APPEAL SUMMARY

Appeal ID: 15362	Project Address: 2390 SE Hawthorne Blvd
Hearing Date: 7/12/17	Appellant Name: Julio Rocha
Case No.: B-020	Appellant Phone: 503 221- 1121
Appeal Type: Building	Plans Examiner/Inspector: Kathy Aulwes
Project Type: commercial	Stories: 4 Occupancy: S-2, R-2, M Construction Type: V-A over 1-A
Building/Business Name:	Fire Sprinklers: Yes - entire structure Full NFPA 13
Appeal Involves: Erection of a new structure	LUR or Permit Application No.: 16-274971-CO
Plan Submitted Option: pdf [File 1] [File 2] [File 3] [File 4] [File 5] [File 6] [File 7] [File 8]	Proposed use: Retail and parking at ground level with housing above

STRUCTURAL CALCULATIONS FIRE DESIGN AT GLULAM BEAMS AT 4TH FLOOR FRAMING PLANS

**PROJECT: 23rd and HAWTHORNE
PORTLAND, OREGON**

1 OVERALL 4TH FLOOR PLAN

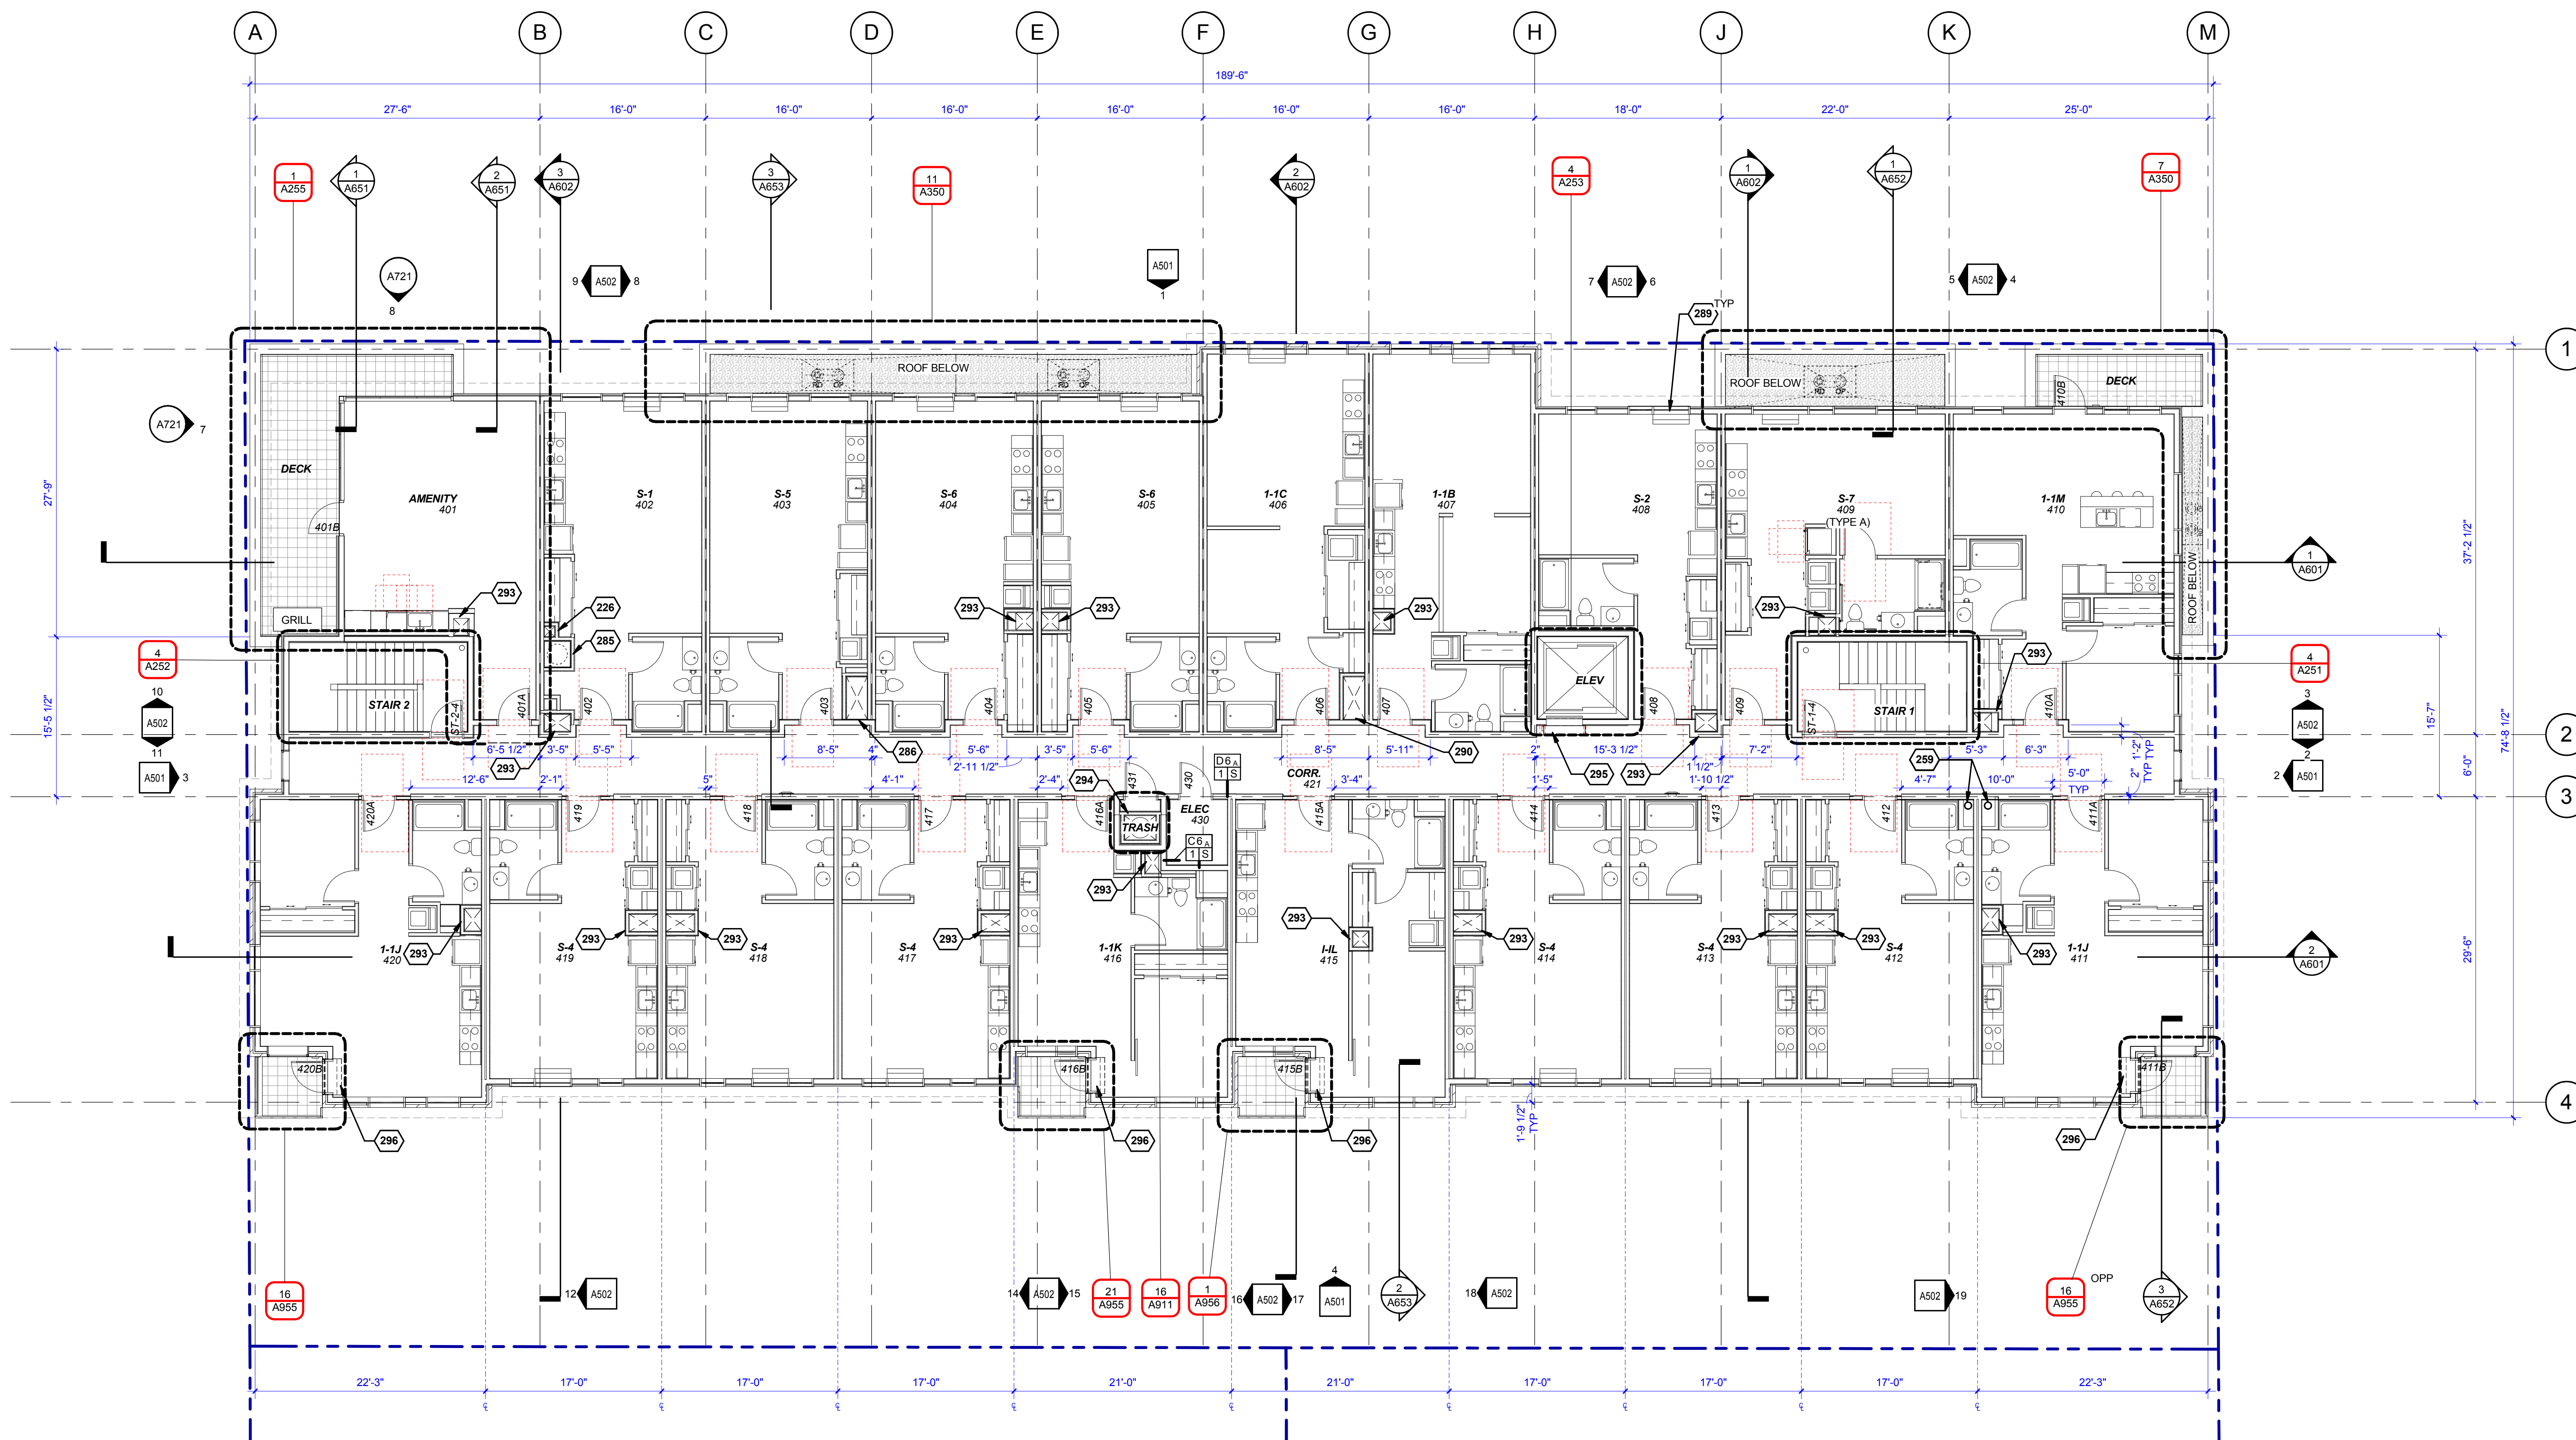
Appeal Item

Calculated one hour fire rating for glulam beams per engineering analysis: Granted as proposed.

**4TH FLOOR
FRAMING PLAN**

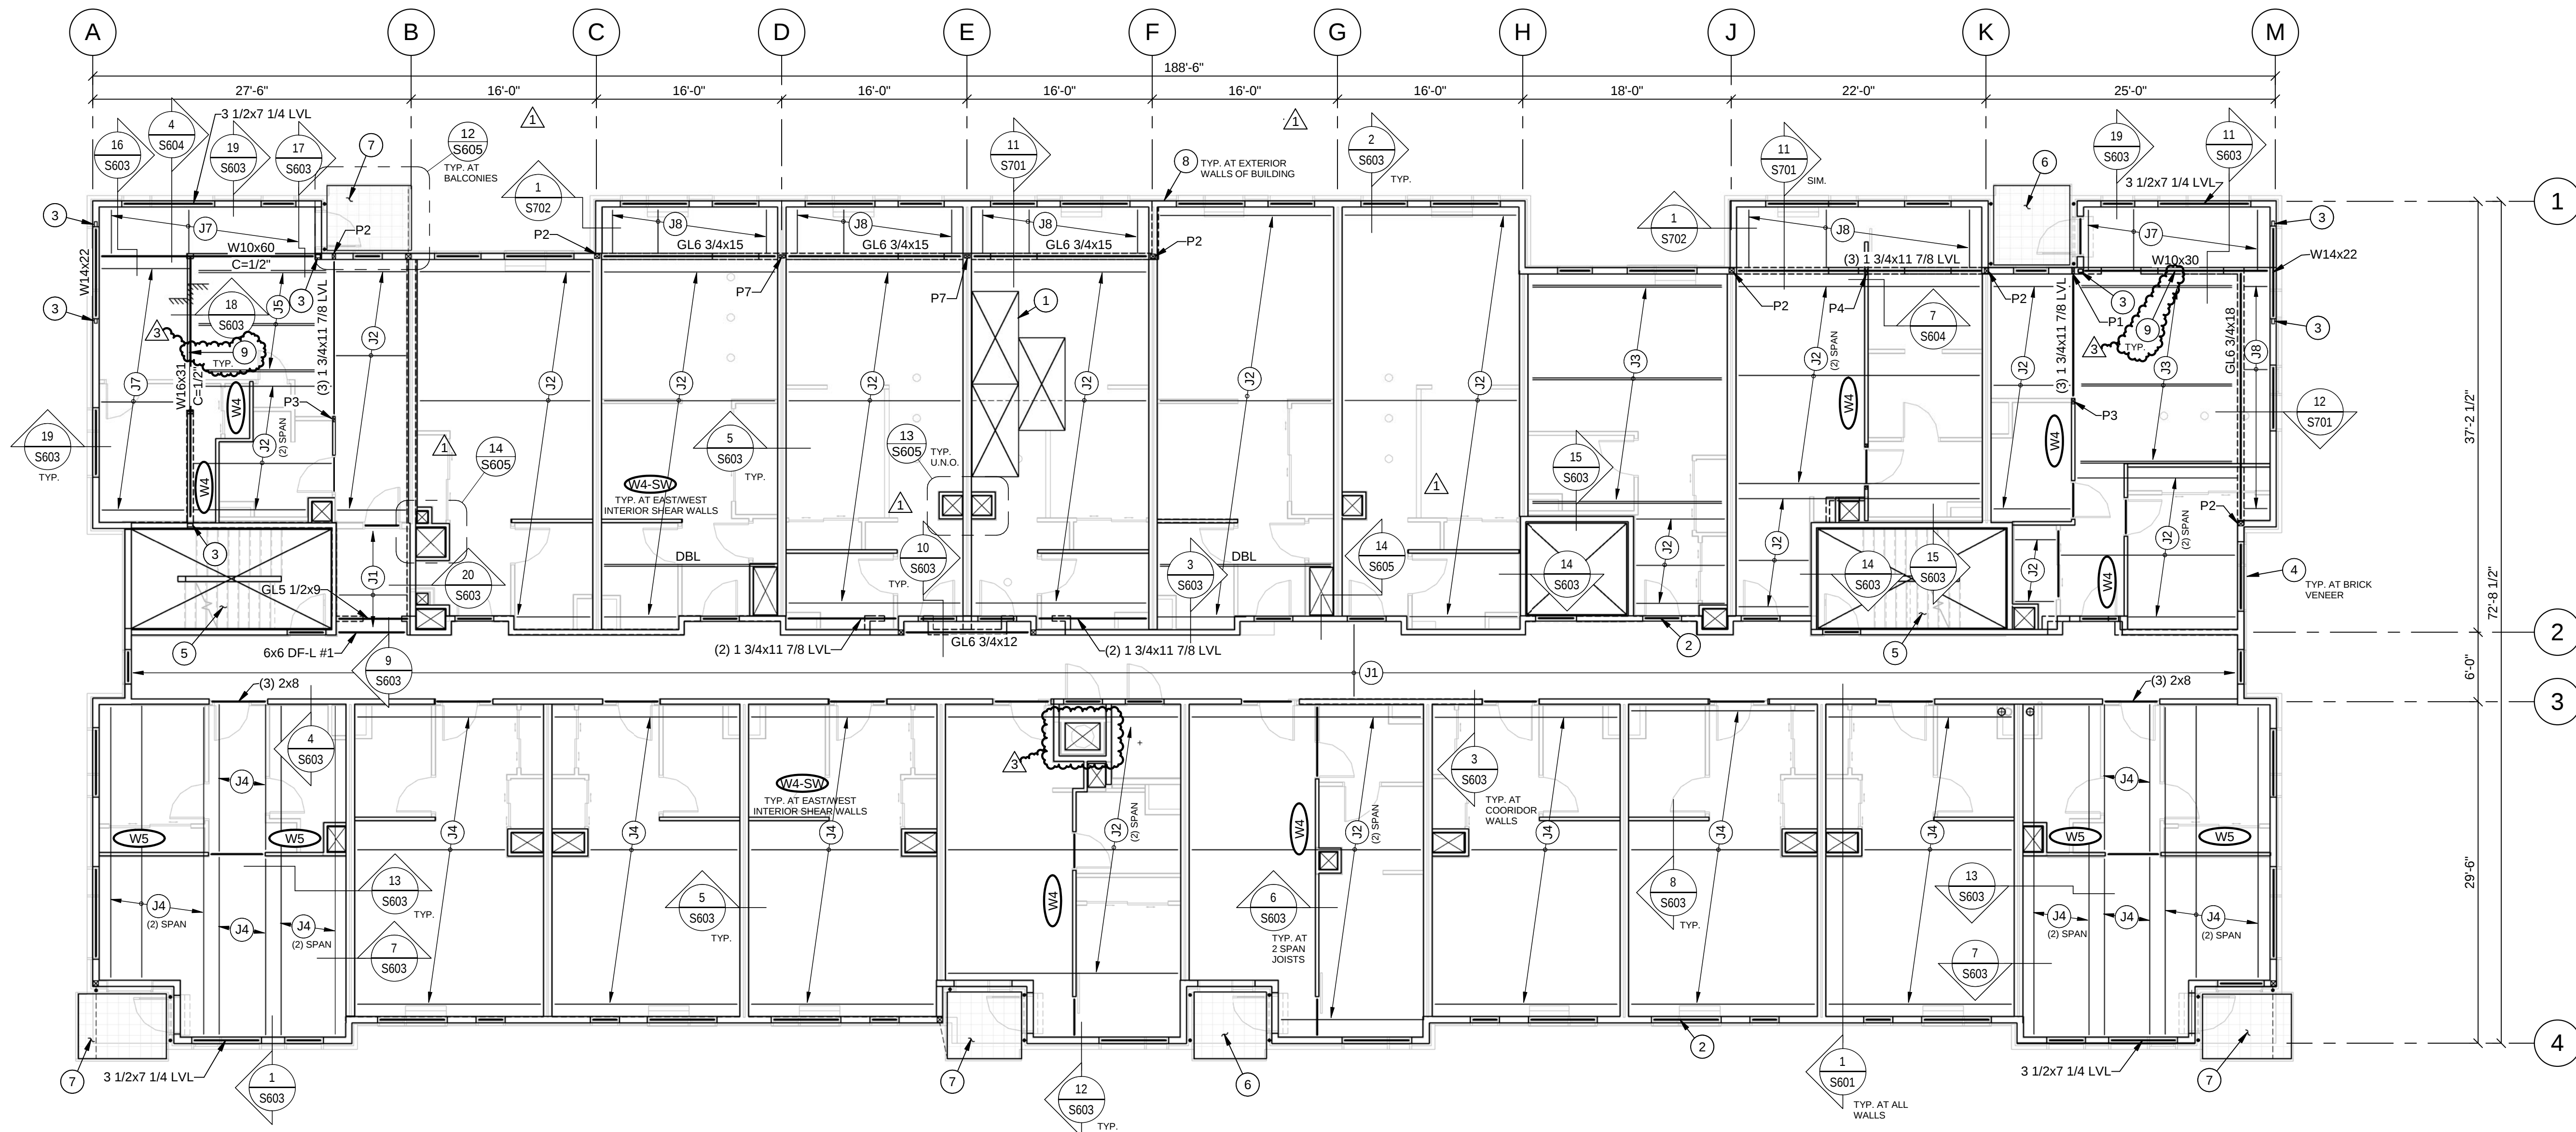
Proposed Design	Primary structural elements are required to be one hour rated per Table 601. We have four glulam beams on level four that our plans examiner is requesting we use the appeal process to indicate the calculations per Section 722.6.3 Equation 7-19. The Glulam beams are 6.75" wide by 15" deep (Grid 1.2 from Grid C to F) and 6.75" wide by 18" deep (Grid K.9 between Grids 1 and 2). Per our Structural Engineer, stamped calculations attached, the beams provide at least one-hour of fire resistance based on standard calculations per Section 722.6.3. Please see attached floor plans, structural plans, and fireproofing structural framing plan.

FOR THREE 6³/₄ x 15 GLB'S THAT DIP BELOW THE CEILING ON ^{4TH FLOOR FL} GRID 1.2 FROM GRID C TO F, THEY HAVE A 60 MINUTE FIRE RATING

CHECK THE 6³/₄ x 18 GLB AT GRID K.9 AT 4TH FLOOR FRAMING!

$T_{\text{FIRE}} = 60.86 \text{ MINUTES} \rightarrow 1 \text{ HOUR FIRE RATED CONSTRUCTION}$

$T_{\text{FIRE}} = 62.15 \text{ MINUTES} \rightarrow 1 \text{ HOUR FIRE RATED CONSTRUCTION}$
